UNITED STATES PATENT AND TRADEMARK OFFICE

APPLICATION NO.	FILING DATE	FIRST NAMED INVENTOR	ATTORNEY DOCKET NO.	CONFIRMATION NO.
09/844,807	04/27/2001	Kraig A. Kirschner	261/178	4280

Office Action Summary	Application No.	Applicant(s) 	
	09/844,807	KIRSCHNER, KRAIG A.	
	Examiner	Art Unit	
	James R. Brittain	3677

DETAILED ACTION

FIG. 4

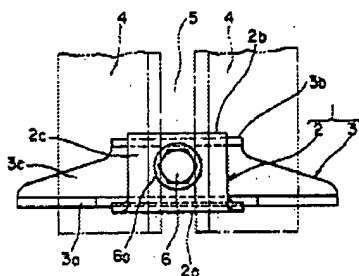
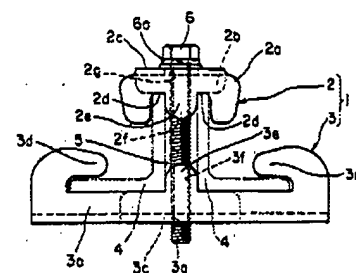
legs by nuts upon a threaded shaft. The threaded shaft extends below the engagement plate and can receive a hanger, which is secured by the lower nut. The prior art described by applicant fails to provide the engagement plate with upstanding engagement portions to either side of the flat anchor portion, the engagement plate extending across the cord space with each upstanding engagement portion having a distal edge with an engagement profile in interlocking engagement with the first legs wherein each engagement portion being at an obtuse angle to the flat anchor portion. However, Koyama (figures 3, 4 and claims 1 and 3-6) teaches a similar suspension system and further suggests in combination the steel web joist including a beam with two angle elements 4, each having a first leg and a second leg, the first legs being parallel with a cord space therebetween and the second legs extending in opposite directions; an anchor plate 2 having a first hole 2g therethrough; an engagement plate 3 including a flat anchor portion 3c having a second hole 3g therethrough and upstanding engagement portions 3a, 3b to either side of the flat anchor portion 3c, the engagement plate 3 extending across the cord space opposite the anchor plate 2, the upstanding engagement portion 3a having a distal edge with an engagement profile defined by central tongue 3e extending between the shoulders 3d, the other upstanding engagement portion 3b has a distal edge with an engagement profile defined by central tongue 3f which interlocks the engagement portion 3b between the first legs so that it will not move laterally to either the left or right as shown in figure 4.

The engagement plate secures interlocks the first legs together by contacting the first legs between the second legs by the tongue 3e. Applicant indicates the structure that provides interlocking engagement in the specification [0006] by stating "In a second separate aspect of the present invention, the engagement plate includes distal edges with tongues extendible to between the parallel legs of the steel web joist beam for interlocking engagement." This establishes that all that is required for interlocking engagement is that the engagement plate distal edges include tongues extendible between the parallel legs of the web joist and Koyama provides such structure in tongues 3e and 3f. While the last sentence of [0006] states, "Shoulders to either side of each tongue may abut against the edges of the legs", the use of the term "may" indicates that the shoulders are not required for interlocking engagement to exist. A stud extends from the first hole 3g to and beyond the second hole 2g, the stud is adapted to secure the anchor plate and the engagement plate to the beam of the steel web joist. The bolt acts as a support for an object suspended therefrom as indicated in claims 3-6 of Koyama. The tongues 3e and 3f are sandwiched by the first legs and act to hold the angle elements at a given interval (col. 3, lines 11-15) and thereby provide better dimensional stability to the beam thereby providing an engineering advantage. Applicant is reminded that "[I]n considering the disclosure of a reference, it is proper to take into account not only specific teachings of the reference but also the inferences which one skilled in the art would reasonably be expected to draw therefrom." *In re Preda*, 401 F.2d 825, 826, 159 USPQ 342, 344 (CCPA 1968). The Koyama reference would suggest to one of ordinary skill in the art that the engagement plate 3 would be prevented from lateral movement by the tongues 3e, 3f being interlocked between the first legs and therefore have the benefit of maintaining the threaded shaft in a position that prevents lateral movement of

FIG. 5

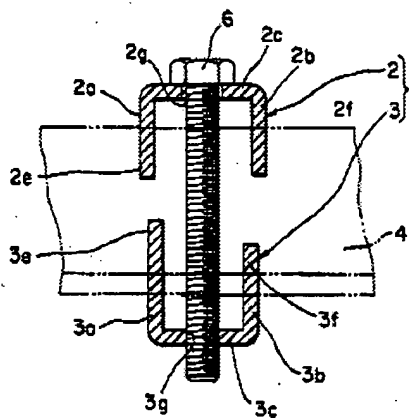
Applicant also argues that the structure of the upstanding engagement portion is more directly aligned with the line of force in lateral seismic responses than would be a flange at a right angle to the anchor portion as found in the remarks on page 6, ¶2, lines 13 through page 7, ¶1, line 2. However, none of this is found in the application as filed and the allegation and whatever benefits derived therefrom is not clear since the line of force in lateral seismic responses extending from a perspective into the paper of the device of Koyama as shown in figure 5 as reproduced below would be just as aligned as though the engagement portions were at obtuse angles to the flat anchor portion.

Force into the paper would be a lateral seismic response and the engagement portion at an obtuse angle would not provide a benefit as it would still be aligned with the engagement portion

Applicant has not established evidence that the particular obtuse arrangement is significant.
